Forsyth County Procurement

ADDENDUM #1

Quote No. 21-112-5211

For: Providing all materials, equipment and labor for Eagle's Beak Park Playground Design and Installation

PLAYGROUND SURFACE DETAIL

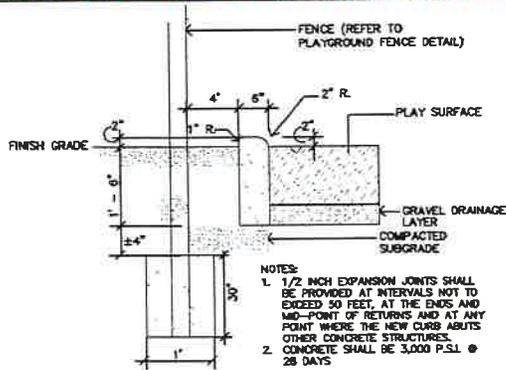
- 1. Q: Does the County have a specification or drawing for the subsurface?**
A: I have attached a recommended architecture drawing for the subsurface, drainage and cement curb. Minimum recommendation would be geotextile fabric, 8" of 57 stone, and at least 12" of engineered wood fiber surfacing (but this will ultimately depend on deck heights and fall zone requirements). Each playground proposal shall detail the recommended design of the playground.
- 2. Q: Does the County have a specification or drawing for the drainage required?**
A: See question #1
- 3. Q: Could you clarify what surfacing the County would like? I am not familiar with synthetic wood chips.**
A: A better description should be "an engineered wood fiber product".
- 4. Q: Does the County have a current vendor for the 4 rail equestrian fence with hog wire mesh that could be shared?**

CONCRETE CURB AT PLAYGROUND

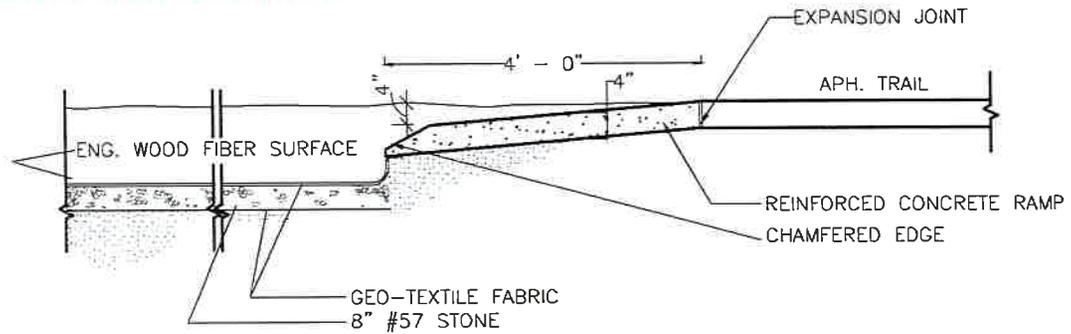
19.Q: Is the 6' curb a typo? Should we be bidding 6" high curbs?

A: *You should be bidding a 6 inch cement curb around the exterior of the area.*
